ADMINISTRATIVE REPORT

| RE: Public Input Report – Valleyview South Master Plan |

Public Input Report on advancing the Valleyview South Master Plan (the Plan) for Council approval on the direction and design concept for a new neighbourhood.

B4. Phasing Concept

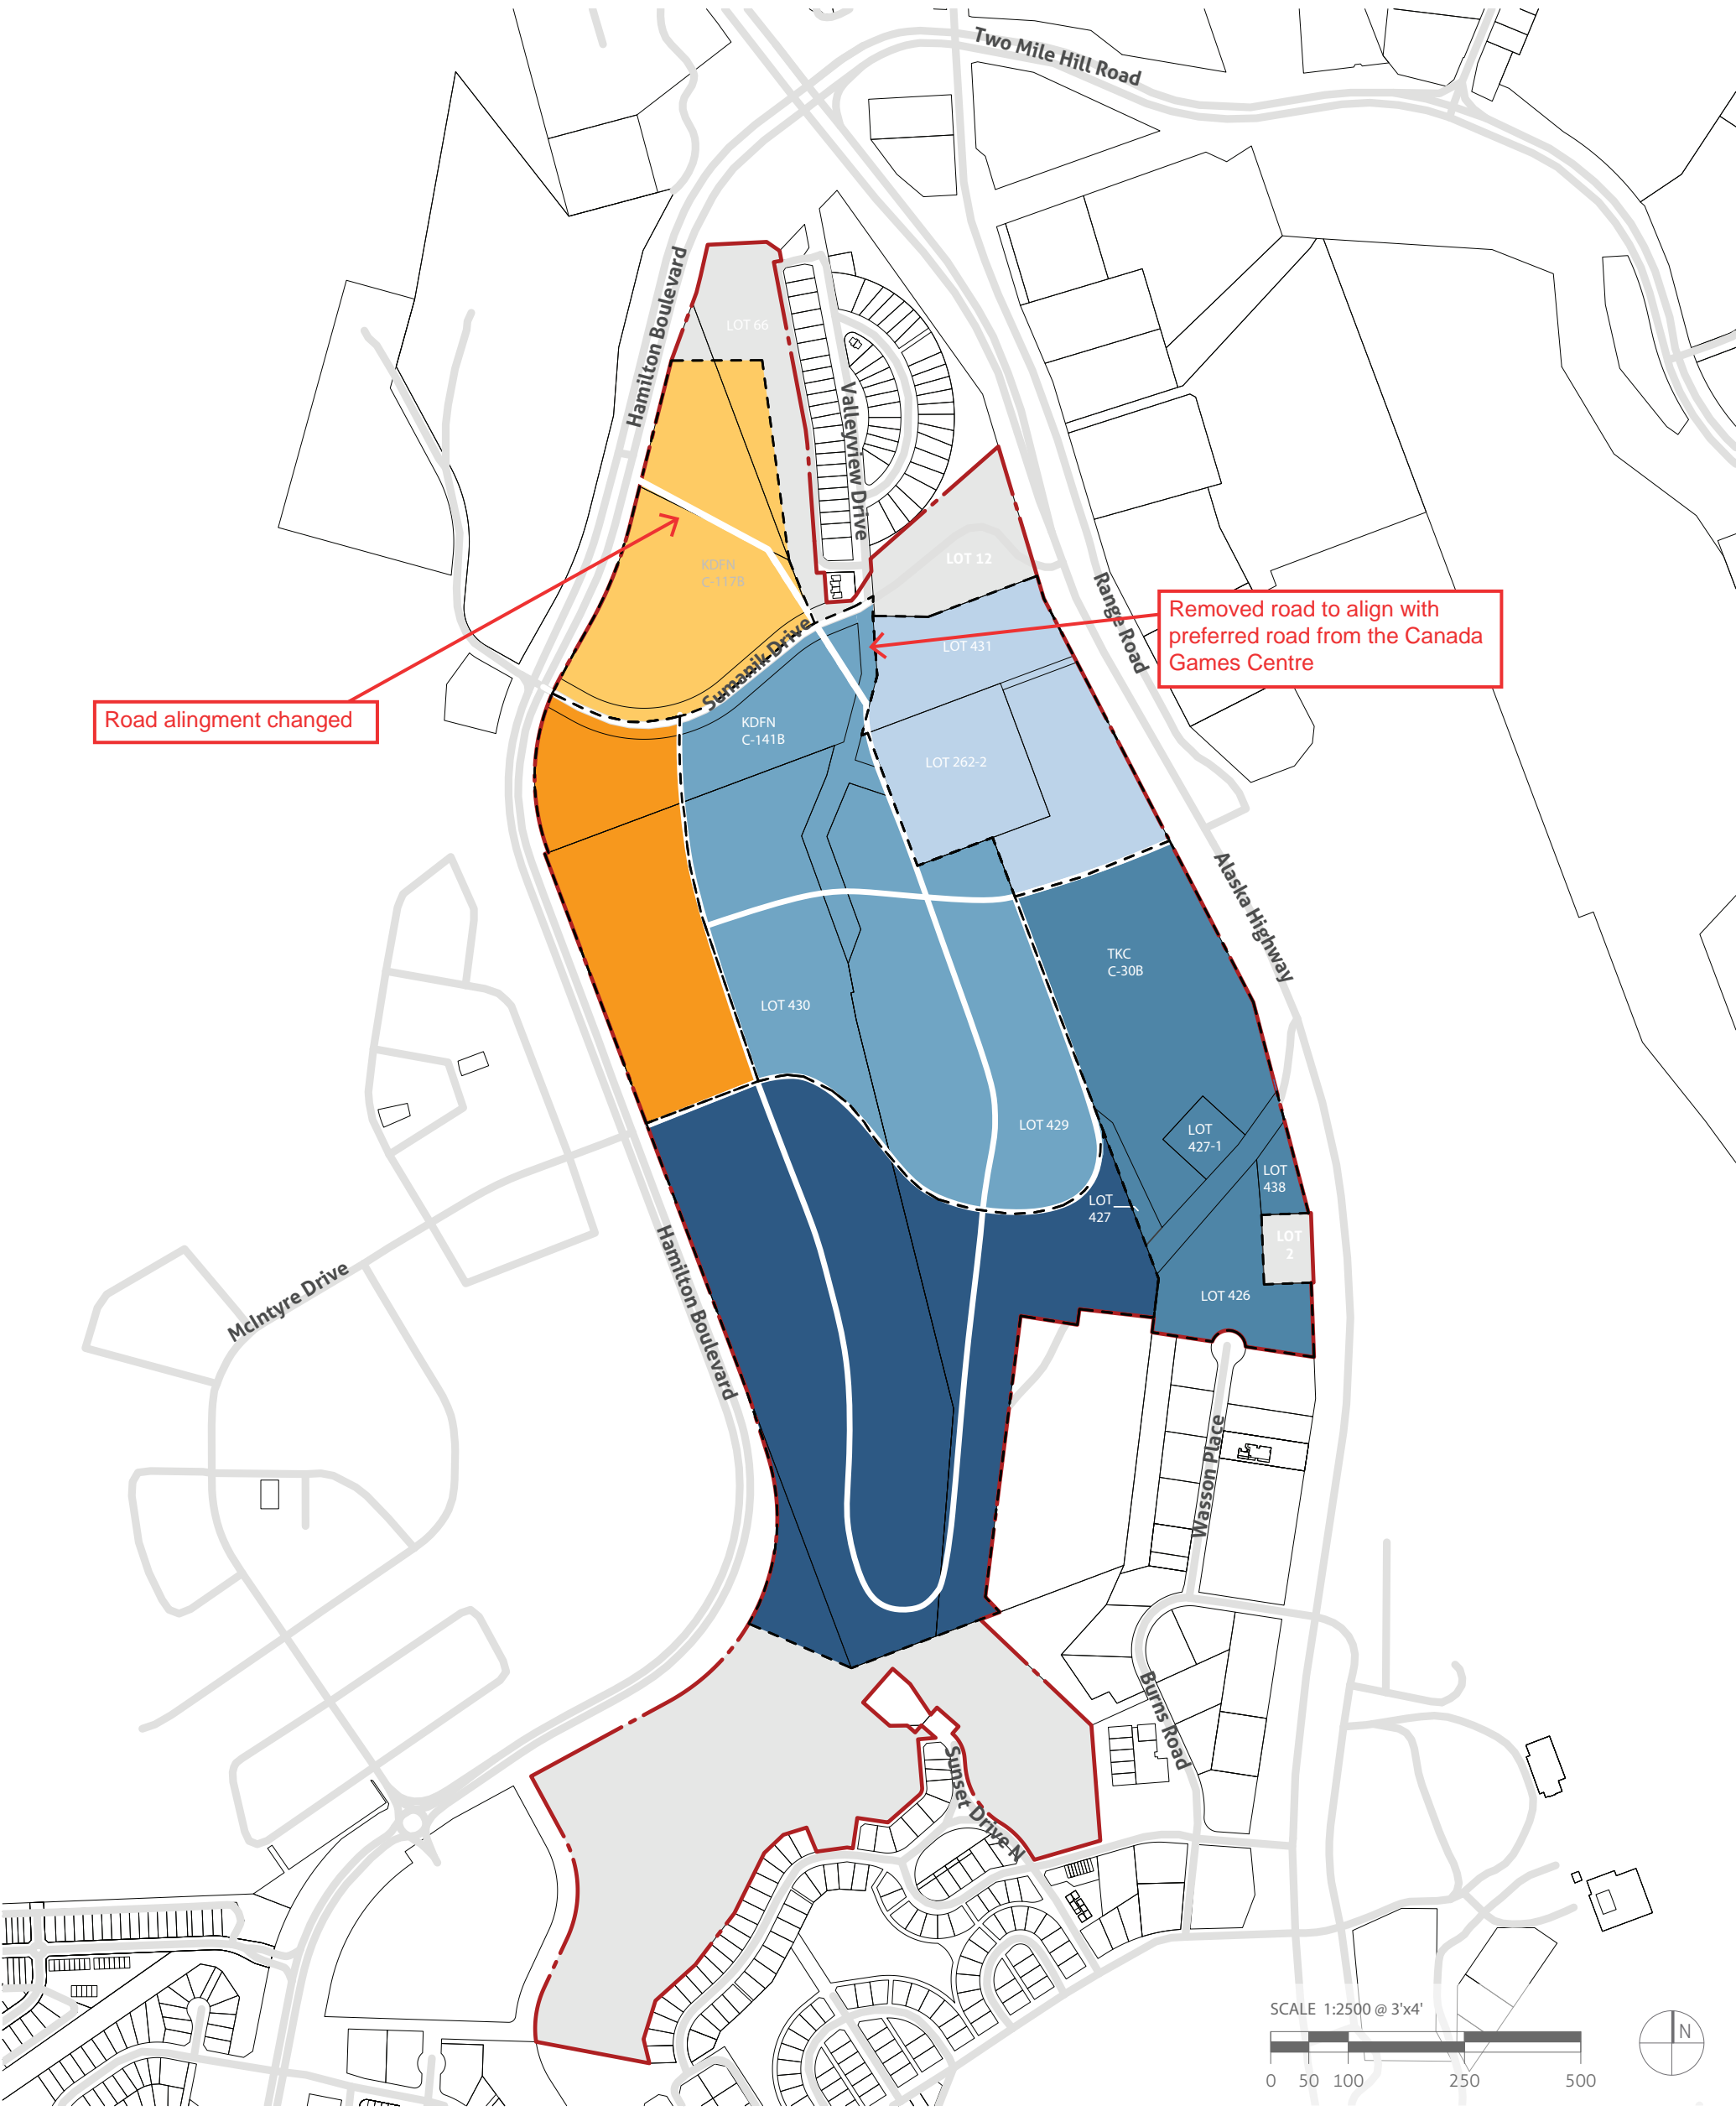
- Replace policy 6.1.2.5 with the following:
“If the recommended road alignment that extends from the CGC into the Valleyview South area is determined to be unfeasible, an alternative road alignment that bisect C-117B and C-141B could be considered.”
- Revise Appendix B maps B1 Land Use Plan, B2 Transportation, and B4 Phasing Concept as illustrated in Attachment 1 of this report.
